## Propeller Shaft Seal - 25, 45/50 (4 Stroke) & 30/40, 40/50, 55/60 (2 Stroke)

### Models Affected

1998 Mariner/Mercury

Mandrel 91-817007

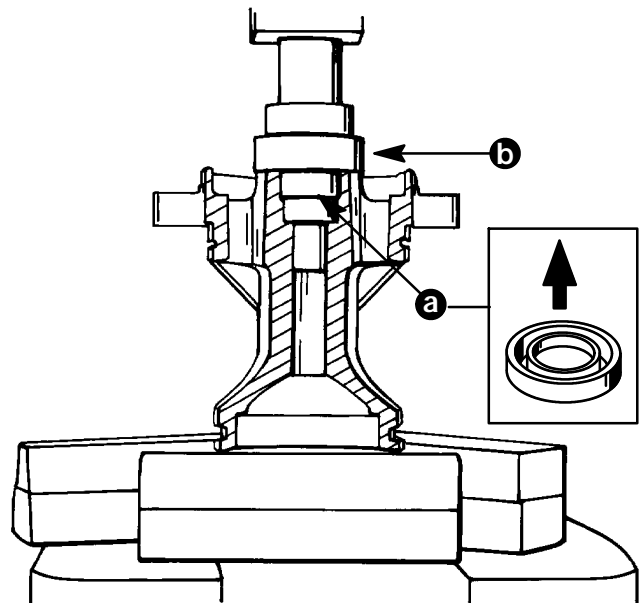
Replace the outer propeller shaft seal on outboards within the serial numbers listed that have not been reworked at the factory. It will be necessary to remove the bearing carrier from the gear housing. Remove and replace only the outer propeller shaft seal. The outer seal is installed with the seal lips facing out. Apply grease between the two seals for extra durability. Refer to the service manual for proper seal installation instructions. Paint the end of the propeller shaft white to identify the installation of the new seal.

a - Outer Seal

b - Mandrel 91-817007

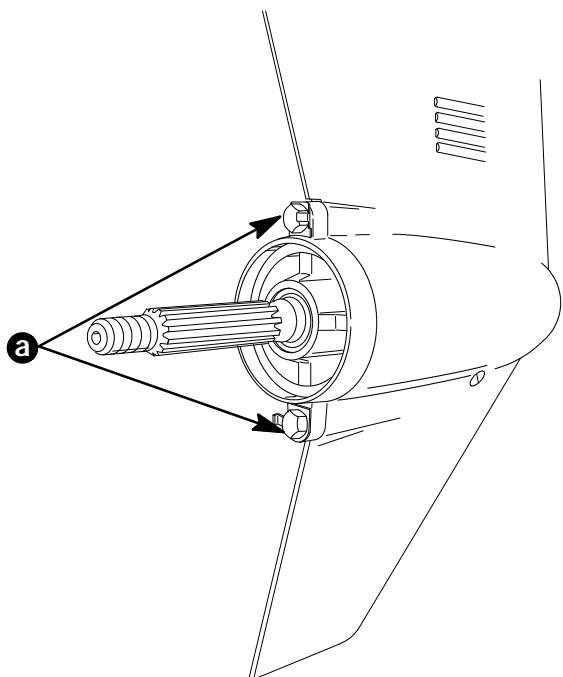
Bearing Carrier Installation: This new service information applies to all the models listed in this service bulletin. Installation of the bearing carrier requires replacement of the original washers and bolts. This change allows for an increase in the bearing carrier bolt torque. Discard any locking tab washers or the previous 0.063 in. (1.60 mm) thick flat washers and the previous 25 mm long bolts. They should be replaced with new 0.090 in. (2.29 mm) thick flat washers p/n 12-855941 and longer 30 mm bolts p/n 10-855940-30. The bolts should be torqued to a higher specification of 225 lb. In./18.7 lb. Ft. (25.4 N·m). The service manuals will have the new procedures and revised torque specification included in the next revision.

### Discard

Tab Washer  
14-826613

Flat Washer  
12-70132  
.063 in (1.60 mm)

Bolt  
10-40003-53  
30 mm Long

### Install

Flat Washer  
12-855941  
0.090 in. (2.29 mm)

Bolt  
10-855940-30  
30 mm Long

a - Torque Bolts to 225 lb. In./ 18.8 lb. Ft. (25.4 N·m).
